UNITED STATES PATENT AND TRADEMARK OFFICE

APPLICATION NO.	FILING DATE	FIRST NAMED INVENTOR	ATTORNEY DOCKET NO.	CONFIRMATION NO.
10/754,394	01/09/2004	Michael Frank Walsh	WMFR-P01-001	9186

Office Action Summary	Application No. 10/754,394	Applicant(s) WALSH, MICHAEL FRANK	
	Examiner Ernesto Garcia	Art Unit 3679

DETAILED ACTION

FIG. 2.

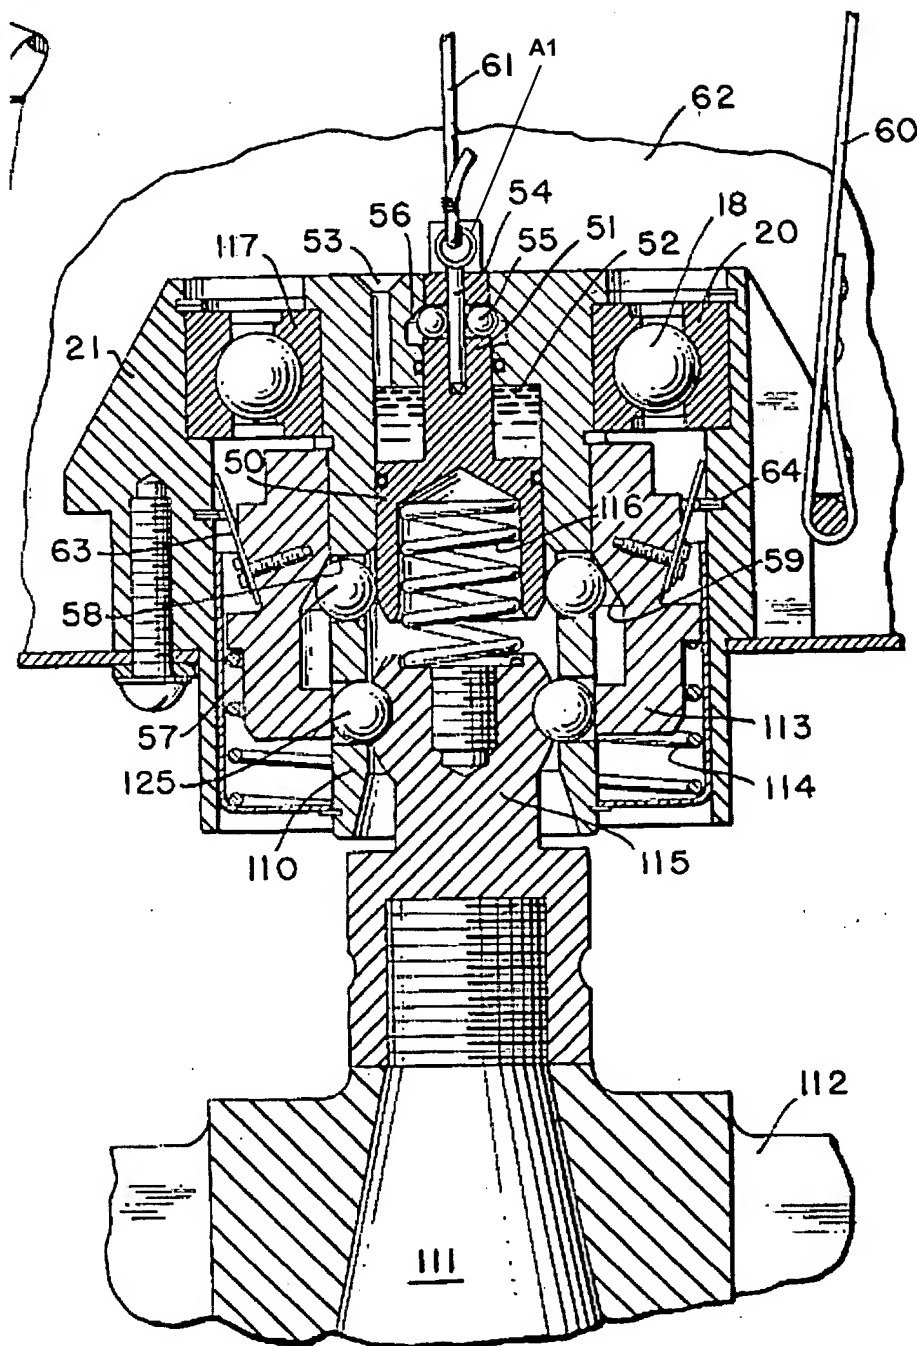
Regarding claim 1, Bemis discloses, in Figure 2, a low-force release mechanism comprising a main structure **110**, a trap **113**, an internal spring pin **51** with an internal spring **116**, a release pin **54**, a least one trigger **A1** (see marked-up attachment), one or more ball bearings **57**, and attachments **125** by which a container **T** is attached to the main structure **110** and the trap **113**. The release pin **54** is configured to be moveable to effect a position of the one or more ball bearings **57** located in the main structure **110** and within an internal geometry of the trap **113**. A load force is distributed to the main structure **110** and to the trap **113** away from the release pin **54**. The one or more ball bearings **57** interact with the internal geometry of the trap **113**. The position of the trap **113** is locked and held. The one or more ball bearings **57** retract upon removal of the release pin such that application of a low force on the trigger **A1** causes the internal spring pin **51** and the release pin **54** to move a position of the container.

Regarding claim 6, Bemis discloses, in Figure 2, a low-force release mechanism comprising a main structure **110**, a trap **113**, an internal spring pin **51** with an internal spring **116**, a release pin **54**, a movable hanger **60**, a least one trigger **A1**, one or more ball bearings **57**, and attachments **125** by which a container **T** is attached to the main structure **110** and the trap **113**. The release pin **54** is configured to be moveable to effect a position of the one or more ball bearings **57** located in the main structure **110** and within an internal geometry of the trap **113**. A load force is distributed to the main structure **110** and to the trap **113** away from the release pin **54**. The one or more ball bearings **57** interact with the internal geometry of the trap **113**. The position of the trap **113** is locked and held. The one or more ball bearings **57** retract upon removal of the release pin such that application of a low force on the trigger causes the internal spring pin **51** and the release pin **54** to move a position of the container.

Regarding claim 9, Bemis discloses, in Figure 2, a low-force release mechanism comprising a main structure **110**, a trap **113**, an internal spring pin **51** with an internal spring **116**, a release pin **54**, a least one trigger **A1** (see marked-up attachment), one or more ball bearings **57**, attachments **125** by which a container **T** is attached to the main

structure **110** and the trap **113**, and a string **61**. The release pin **54** is configured to be moveable to effect a position of the one or more ball bearings **57** located in the main structure **110** and within an internal geometry of the trap **113**. A load force is distributed to the main structure **110** and to the trap **113** away from the release pin **54**. The one or more ball bearings **57** interact with the internal geometry of the trap **113**. The position of the trap **113** is locked and held. The string **61** is attached to the trigger **A1**. The one or more ball bearings **57** retract upon removal of the release pin such that a user pulling on the string **61** causes the internal spring pin **51** and the release pin **54** to move a position of the container such that the container collapses releasing its contents.

Regarding claim 11, Bemis discloses, in Figure 2, a low-force release mechanism comprising a main structure **110**, a trap **113**, an internal spring pin **51** with an internal spring **116**, a release pin **54**, a least one trigger **A1** (see marked-up attachment), one or more ball bearings **57**, attachments **125** by which a container **T** is attached to the main structure **110** and the trap **113**, and a trap spring **114**. The release pin **54** is configured to be moveable to effect a position of the one or more ball bearings **57** located in the main structure **110** and within an internal geometry of the trap **113**. A load force is distributed to the main structure **110** and to the trap **113** away from the release pin **54**. The one or more ball bearings **57** interact with the internal geometry of the trap **113**. The position of the trap **113** is locked and held. The trap spring **114** and the ball bearings **57** interact with the geometry of the trap **110**. The one or more ball bearings **57** retract upon removal of the release pin such that application of a low force

on the trigger **A1** causes the internal spring pin **51** and the release pin **54** to move a position of the container.
